# THE UNIVERSITY OF NORTH CAROLINA AT CHAPEL HILL

## REQUEST FOR PROPOSALS (RFP) ADDENDUM

RFP Number: RFP020625AMG

Addendum Number: 2

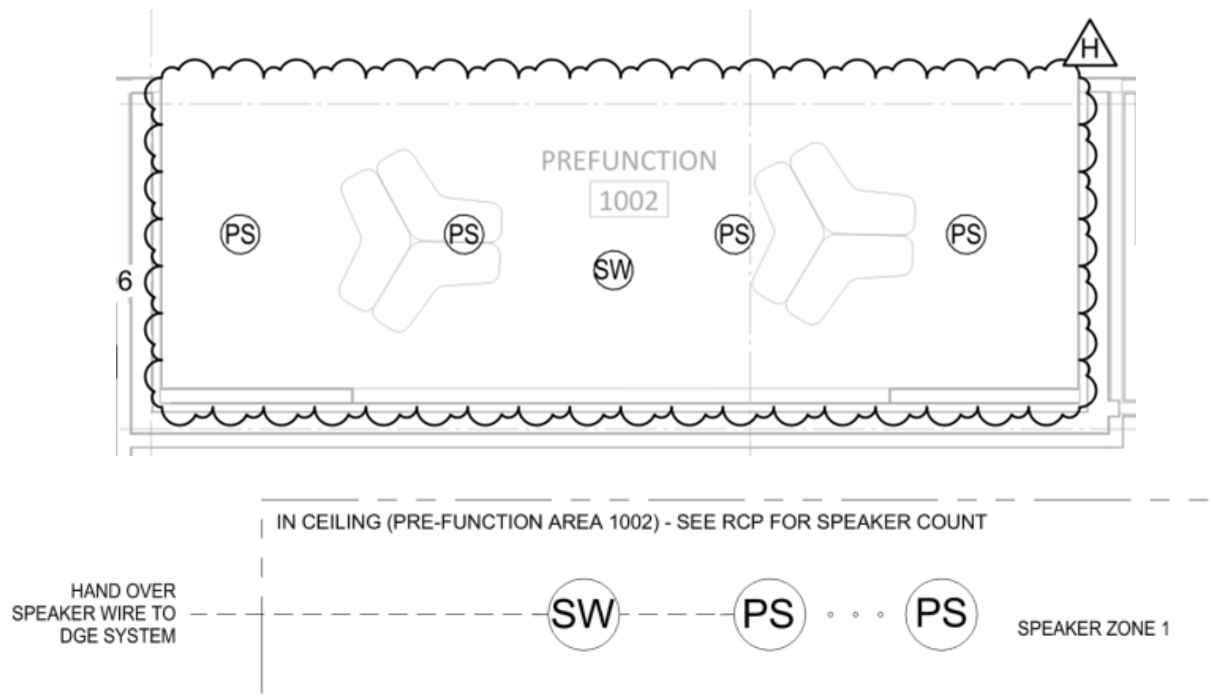
E. On AV-201C (Infrastructure Drawing Set), the ceiling type in Prefunction 1002 has changed to a wood slat type ceiling.

Provide and install one (1) subwoofer and four (4) pendant speakers to match those indicated on the Bell Building Equipment Worksheet for System Type 6. These replace the speakers previously shown in this area.

Reference the images below.

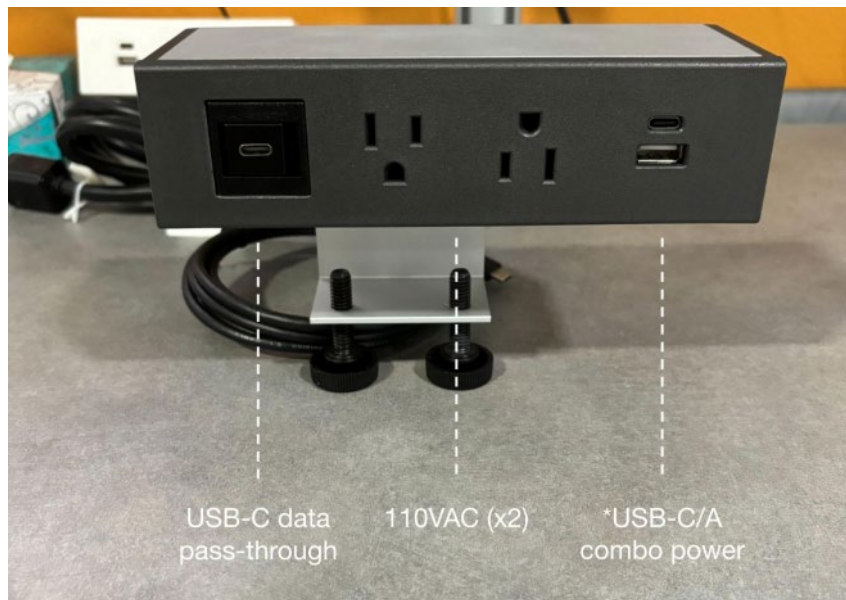
- H. Provide and install one (1) power module for each instructor station. The power module shall be Steelcase STUGRGPOWER and shall provide the receptacles shown in the image below.
